**Wyoming Department of Environmental Quality (WDEQ) Land Quality Division (LQD)**

**Memorandum**

File: Lost Creek ISR, LLC – WDEQ/LQD Permit 788  
To: John Saxton, NRC  
From: Melissa Bautz, WDEQ/LQD  
Date: December 9, 2013 *MMZB*  
Subject: Excerpts from WDEQ/LQD Permit 788 – Lost Creek ISR Project

**FIGURE OP-5d**  
**Project Water Balance**  
**Production with RO**

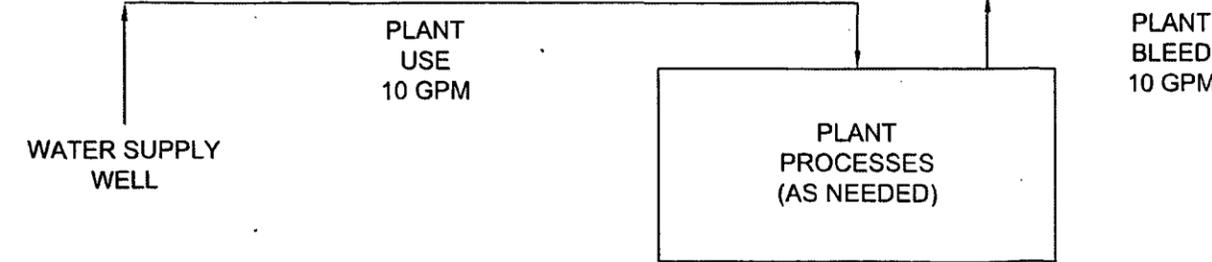
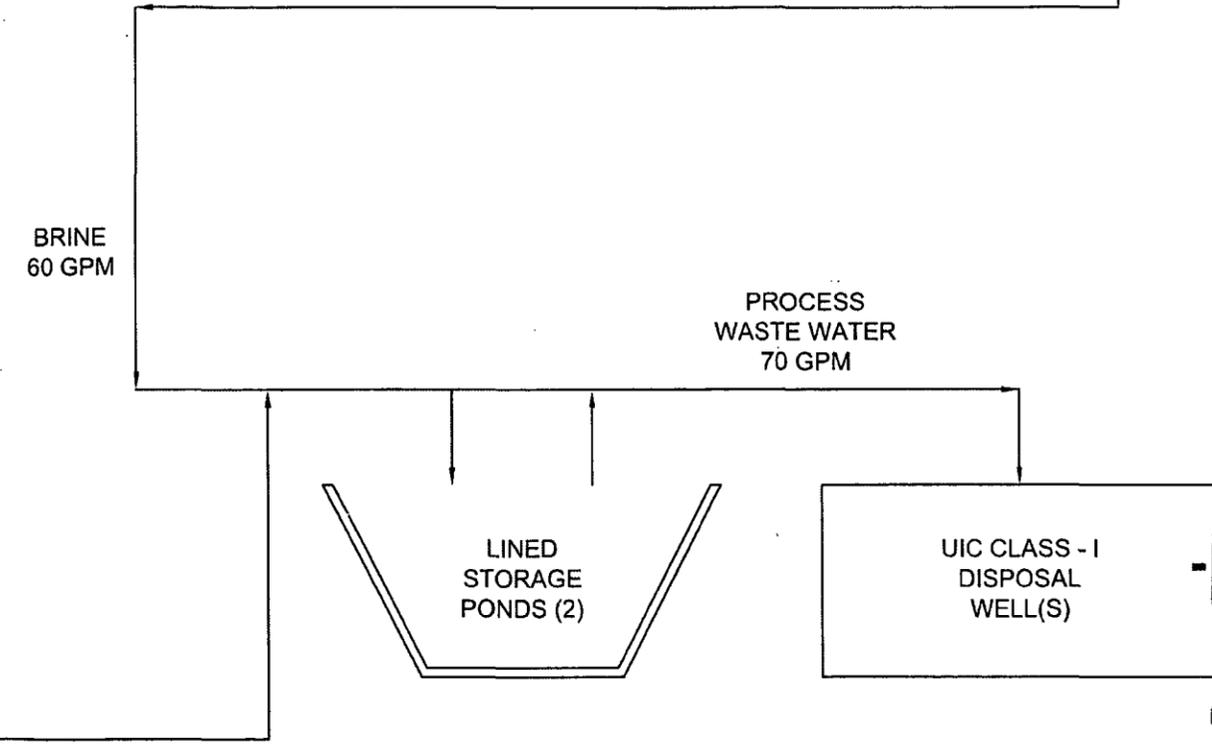
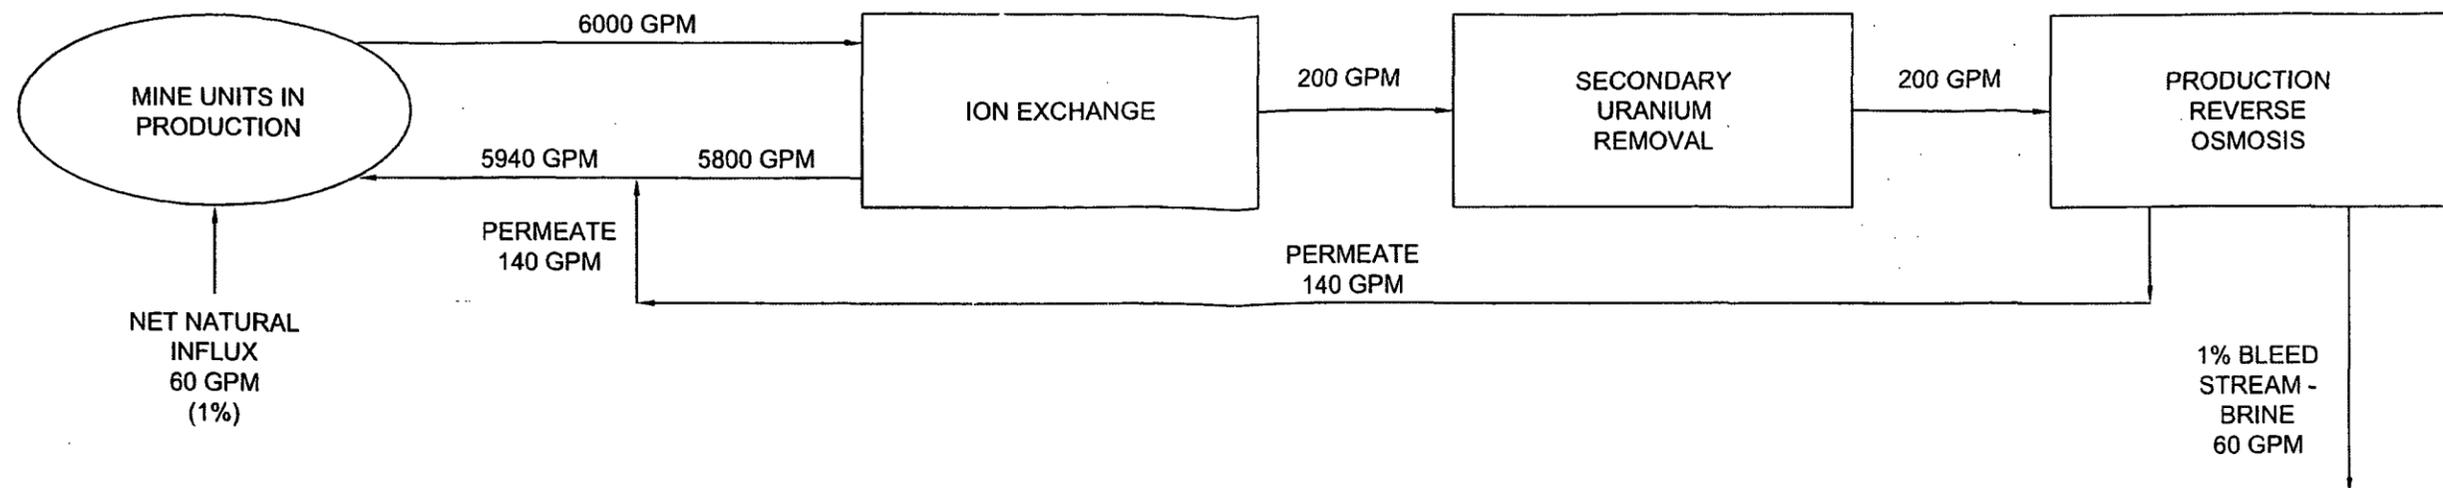
Figure OP-5a	Figures	This figure is the project water balance diagram for mining only. In the top left portion of the diagram, a 1% bleed is stated.
Figure OP-5d	Figures	This figure is the project water balance diagram for mining and RO operations running simultaneously. In the top left portion of the diagram, a 1% bleed is stated.
